# REGIONAL REVIEW FINDING

**ARC REVIEW CODE:** R2107231

**Name of Proposal:** Mixed-Use Development at Peachtree-Wieuca DRI #3383

GSWCC NO. (LEVEL II) 0000068765  
DRAWN BY ATB  
DESIGNED BY IDK  
REVIEWED BY BWS  
DATE 07/12/2021  
PROJECT NO. 012826043  
TITLE DRI SITE PLAN  
SHEET NUMBER DRI-1

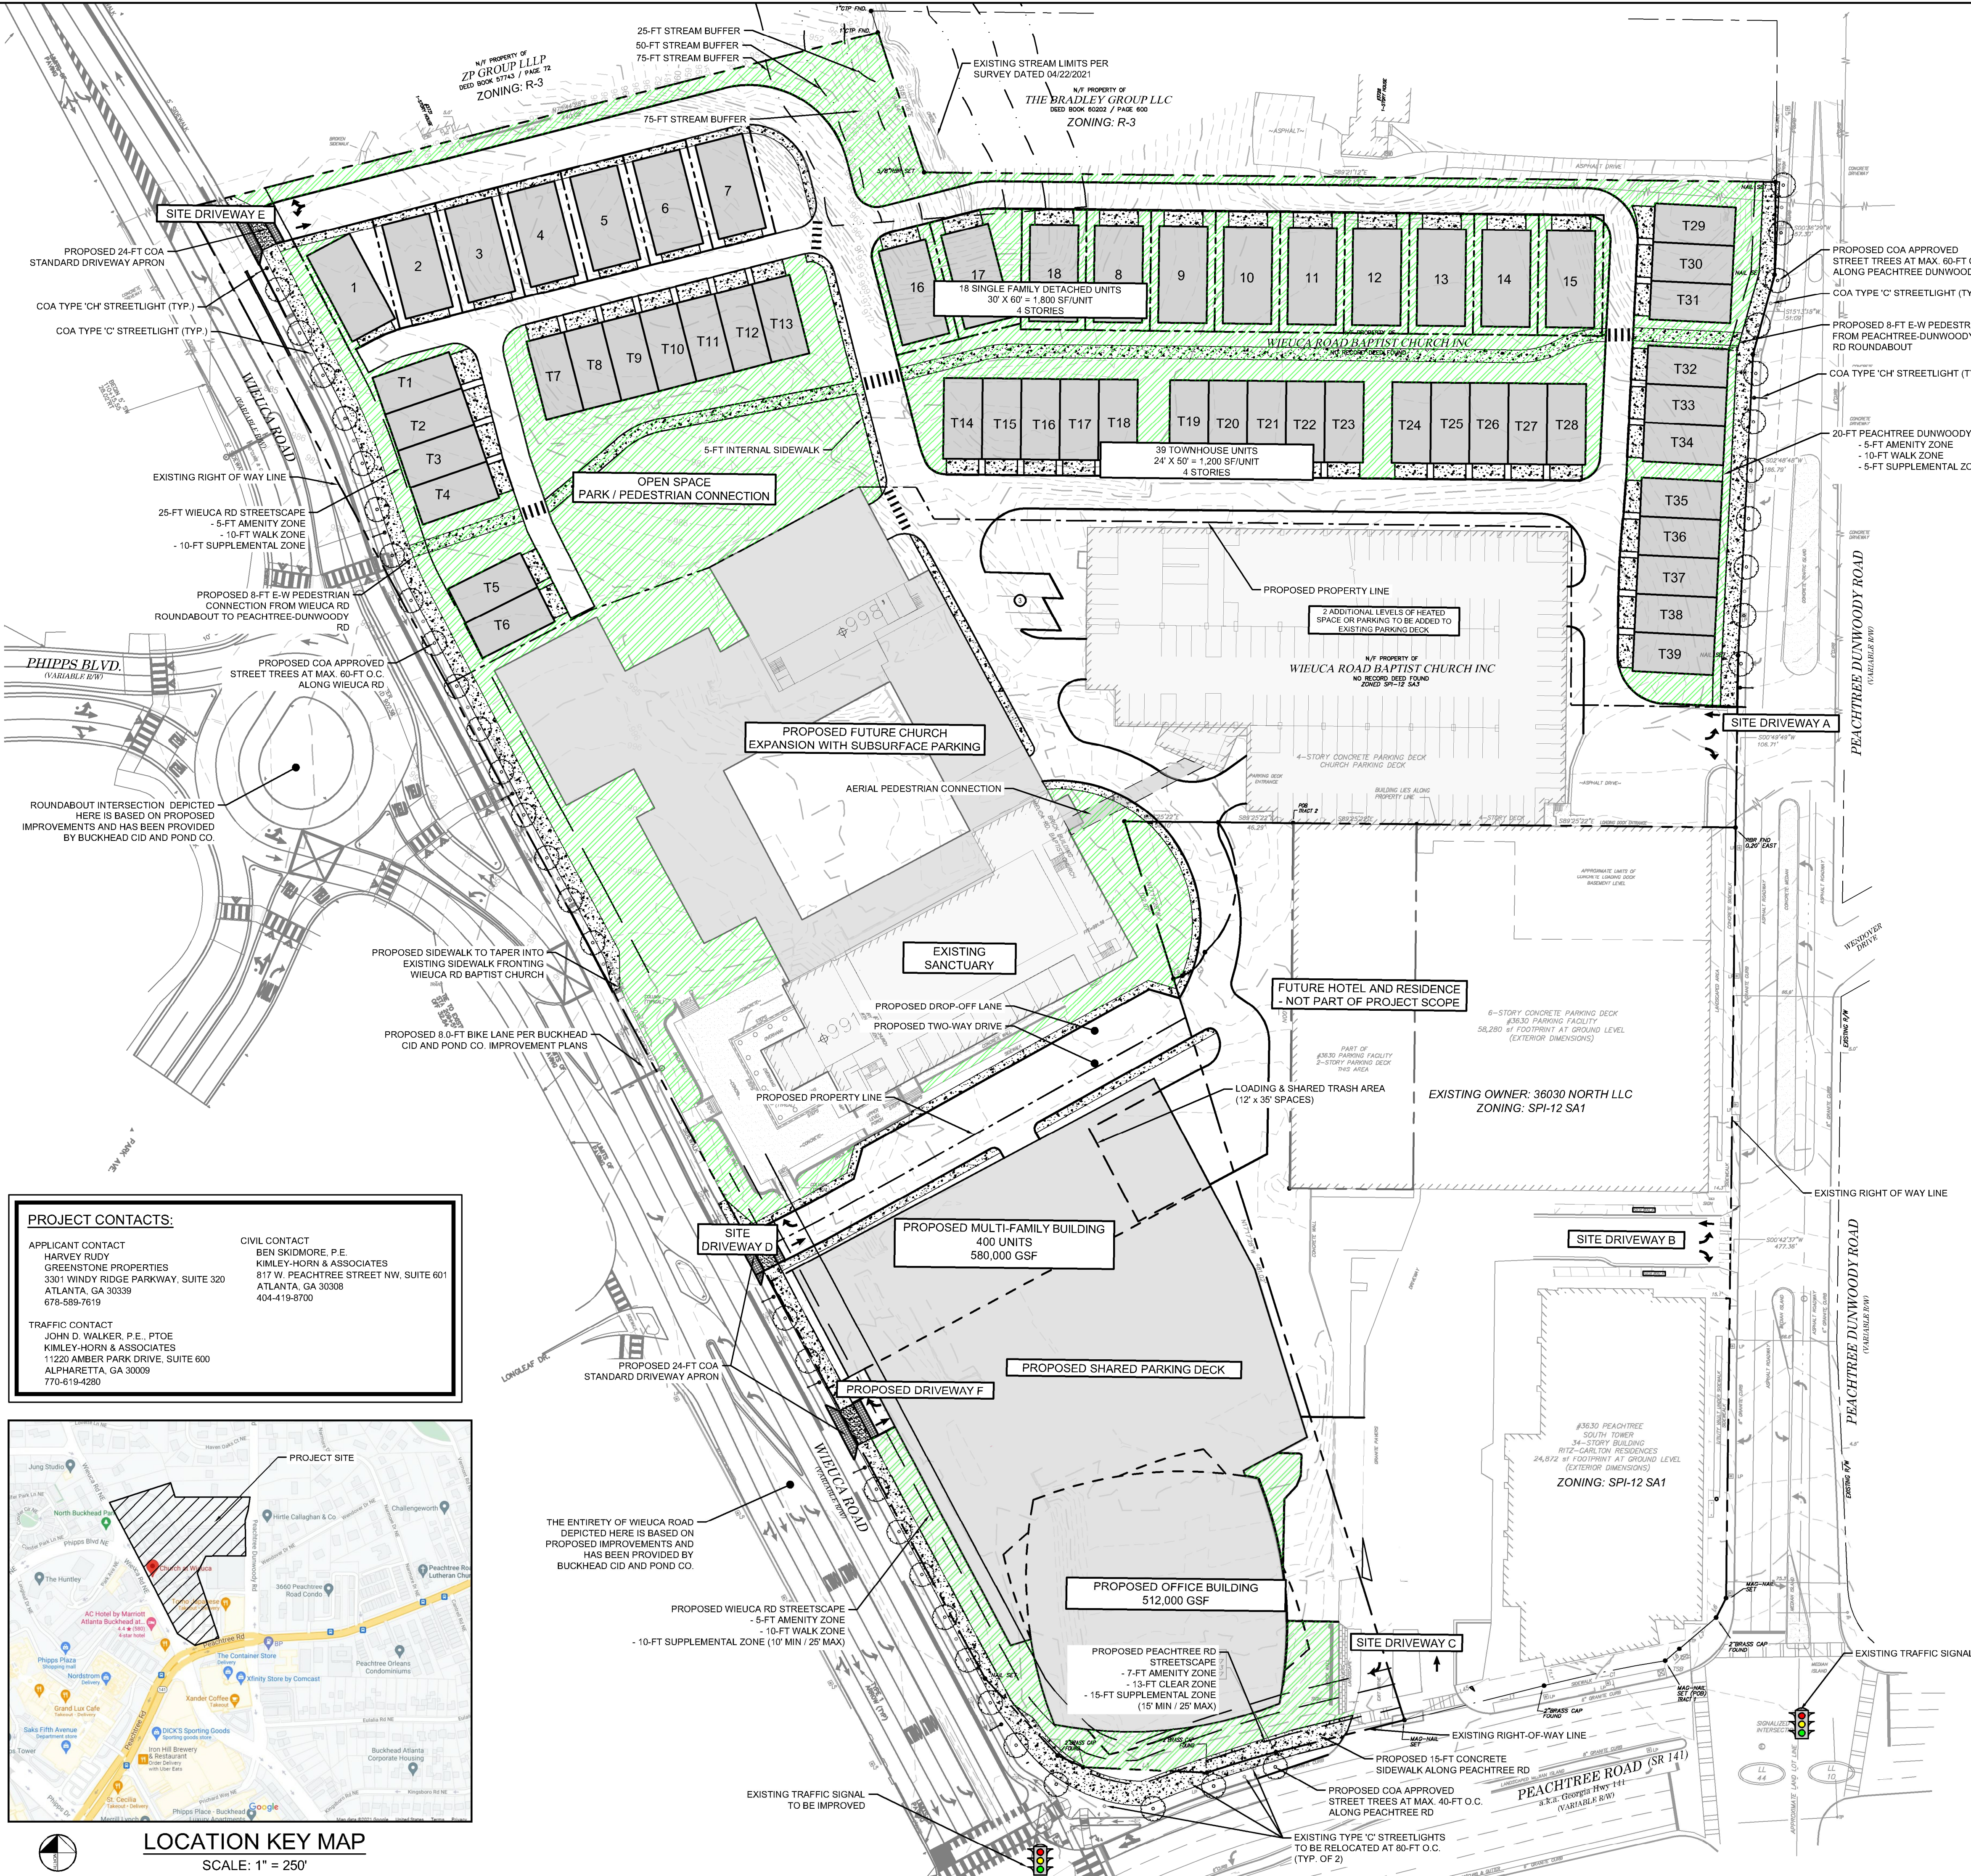
Comments received from the City of Atlanta Department of Transportation (ATLDOT) are attached. They suggest consolidating or minimizing the number of driveways on Wieuca Road to increase bike/ped safety and reduce vehicular conflicts. One specific recommendation is the removal of Driveway F. They also suggest changing Driveway E to a right-in/right-out only condition as left turns from Driveway E would cross multiple lanes plus the cycle track and potentially create conflicts and unsafe conditions. Southbound movement can be accommodated via Driveways C and D. Lastly, ATLDOT's comments recommend pedestrian crossings at Longleaf Drive and across Peachtree Dunwoody Road at the northeast corner of project.

Additional comments on water resources from ARC's Natural Resources Group are attached. They indicate that the DRI site plan shows a stream starting in the north central portion of the property. The applicable City 50-foot undisturbed buffer and 75-foot impervious setback are shown, along with the required State 25-foot Erosion and Sedimentation Act buffer. The stream and the buffers are crossed by a proposed driveway, however, so this and any other intrusions into the buffers may require City and/or State variances.

- Suggest consolidating or minimizing the number of driveways proposed on Wieuca Rd to increase pedestrian and bicycle safety, as well as reduce vehicular conflicts. It is suggested to remove the “proposed Driveway F” since Site Driveway D can be used to access the site and access to the parking deck should be mitigated through Driveway D.
- Reconsider the permissible left turn movement from “Site Driveway E”. This should be in/right out only. Crossing numerous lanes plus the cycle track creates numerous potential for conflicts and unsafe conditions. Anyone looking to head southbound could use “Site Driveway D” to use the roundabout or “Site Driveway C”.
- Consider pedestrian crossing installation at Longleaf Drive.
- Add pedestrian crossing across Peachtree Dunwoody at the pedestrian connection at NE corner of development.

The USGS coverage for the project area does not show any streams on or near the property. However, the submitted site plan shows a stream starting in the north central portion of the property. The City 50-foot undisturbed buffer and 75-foot impervious setback are shown, as is the State 25-foot Erosion and Sedimentation Act buffer. The stream and the buffers are crossed by a proposed driveway. This and any other intrusions into the buffers may require variances. Any unmapped streams on the property may be subject to the City's Stream Buffer Ordinance. Any waters of the state that may be on the property will be subject to the State 25-foot Erosion and Sedimentation Buffer requirements.
